Product Change Notification

Product Change Notification: E-19-007049

DEUTSCH DT13/15 SERIES HEADER RECEPTACLE PACKAGING.

Before

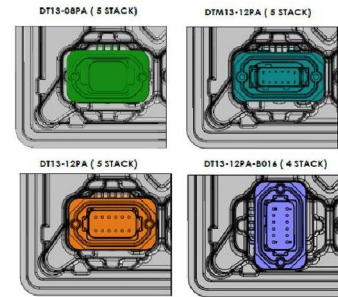
Packaging Change. Change packaging from Chipboard partitions to PCV plastic formed trays. Also change box carton to meet standard per AIAG (Automotive) type and quantity per box.

After

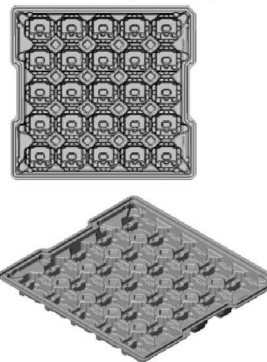
- PCV antistatic plastic trays
